**IDAP REPORT**

<b>Property:</b>	2 Wakeford Road Strathfield Lot: 7 DP: 211 DA2021.267
<b>Proposal:</b>	Demolition of existing structures, construction of a two (2) storey dwelling house with basement level, in-ground swimming pool, outbuilding and associated landscaping works.
<b>Applicant:</b>	Design Workshop Australia
<b>Owner:</b>	M Taouk
<b>Date of lodgement:</b>	27 October 2021
<b>Notification period:</b>	2 November 2021 – 16 November 2021
<b>Submissions received:</b>	Nil
<b>Assessment officer:</b>	J W Brown
<b>Estimated cost of works:</b>	\$979,000.00
<b>Zoning:</b>	R2-Low Density Residential - SLEP 2012
<b>Heritage:</b>	No
<b>Flood affected:</b>	No
<b>Is a Clause 4.6 Variation Proposed:</b>	No
<b>RECOMMENDATION OF OFFICER:</b>	<b>APPROVAL</b>

Figure 12: Original basement (left) amended basement (right)

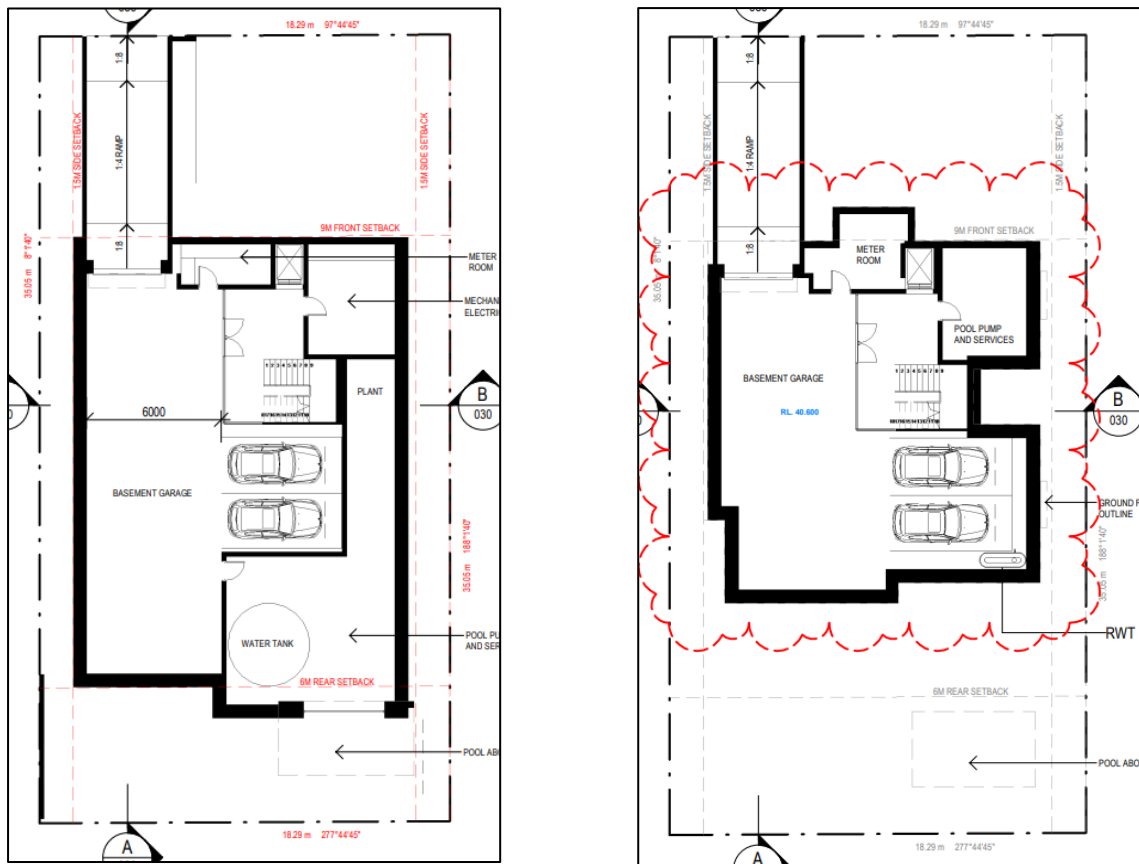
The proposed development satisfies the relevant objectives and most of the controls of the SCDP 2005 in that it provides the minimum number of required parking spaces and adequate vehicular access provisions. The basement has been kept to less than 1m above natural ground level. The basement size has been reduced in the assessment however, a design condition is recommended to reduce the meter room to not extend beyond the ground floor above. The basement has been designed so that vehicles can enter and exit in a forward direction and maintains a minimum internal height of 2.2m. To reduce excavation of the site a design condition will be recommended for maximum floor to ceiling height in the basement to be 2.4m. Further, the driveway and ramp will be conditioned to be a maximum of 3.5m and the driveway width at the boundary to be 3m; to comply with SCDP 2005. This is likely to increase landscaping and provide a further setback to the street tree.

Basement Meter Room	The Basement Meter Room is to be reduced in size to not extend beyond the ground floor above. The ground floor does not include the front porch.
Driveway width	The vehicular access driveway and ramp width must be reduced from the proposed 3.6metres to 3.5metres to achieve a maximum allowed width of 3.5m. Driveway width at the boundary must be reduced to 3m as specified by the SCDCP 2005. Any front fence or gate opening adjustments required as a result of this reduction must be illustrated on the plans lodged with the application for the Construction Certificate.
Basement Height	To limit excavation, the basement is to have a maximum floor to ceiling height of 2.4m.
Beam and Wall	The beam and wall is to be removed between the swimming pool and living room to ensure landscaped area will not be covered
